March 2025 | Danfoss Climate Solutions for cooling

# TECH INSIDER

## Notification of Change in Compressor Label Format for All Reciprocating Compressors MT, MTZ, NTZ, VTZ

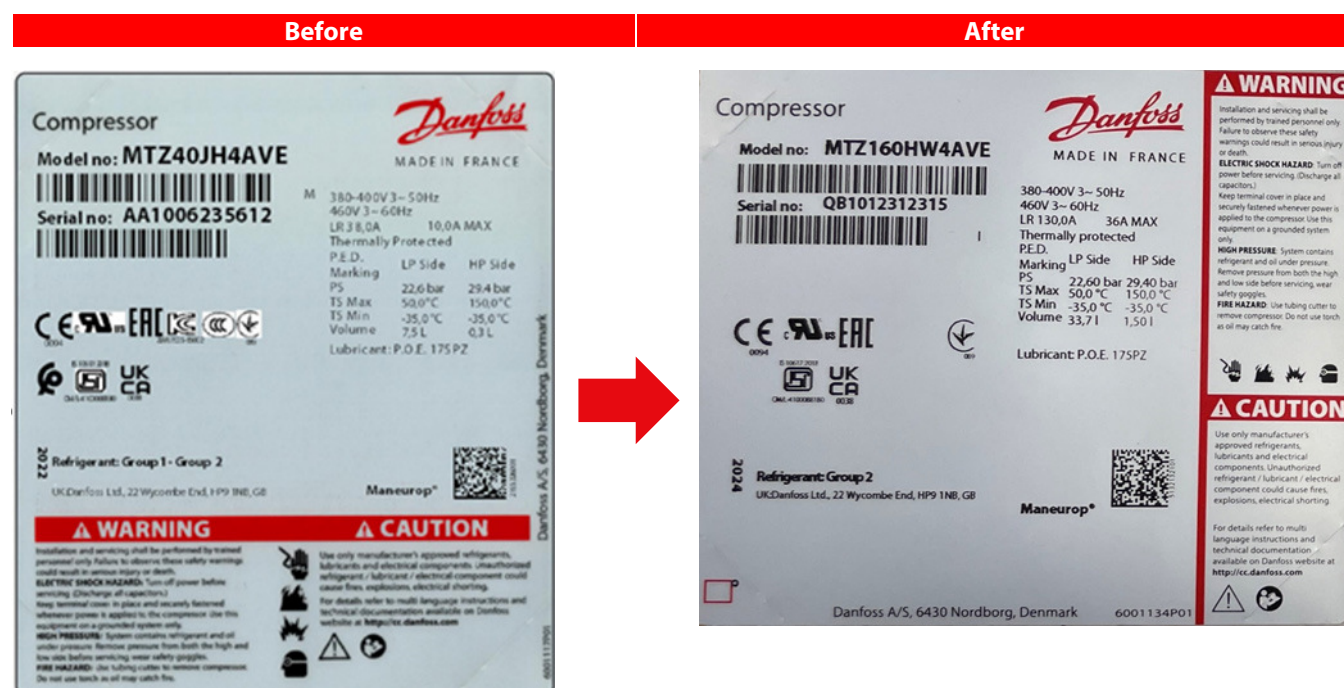
This is to inform you about an upcoming change in the format of our compressor labels. The shape of the label will transition to a horizontal version, commonly referred to as landscape.

All data on the label will remain unchanged; only the layout will be adjusted to better fit the compressor housing.

The images below illustrate the label before and after the change.

## Optyma™ Slim Pack DS034 Piping Change

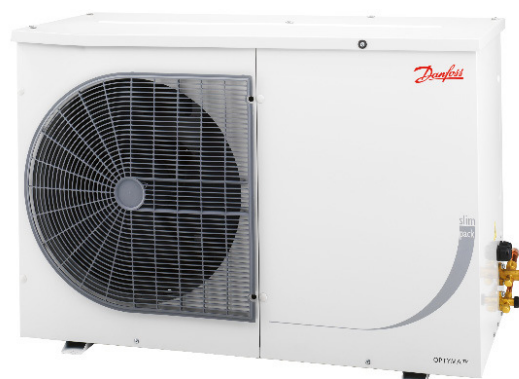
As part of Danfoss' continuous quality monitoring, due to infrequent and extremely rare abnormal vibration discovered in the field under very specific working conditions, we are pleased to announce that we have changed the discharge tube piping design for four models to prevent possible leakage and ensure reliable operation for years to come under all intended working conditions.

Under specific working conditions Optyma Slim Pack models equipped with the Danfoss DS34TB compressor have exhibited high vibration levels. In very few field cases, abnormal noise has been detected after several months of operation, which potentially might result in cracks on the compressor discharge port and subsequent system leaks.

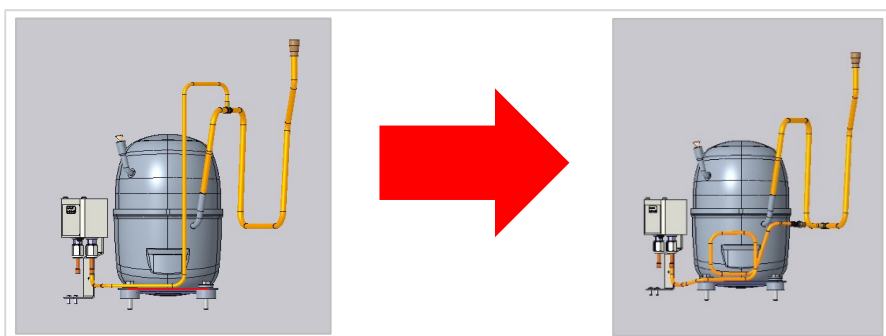
All Optyma Slim Pack with DS034 compressors.

The DS34TB compressor exhibits higher vibration than the initial levels documented during the engineering of this model. This resulted in uncomplete vibration simulation and consequent design of the discharge piping line.

The new design will ensure the flexibility and reliability of the brazed parts.

For products on field and abnormal vibrations experienced, produced before this date we have created a kit to change the piping – there is no need for pro-active modification if no abnormal vibration experienced.

- Kit article code: 118U5588
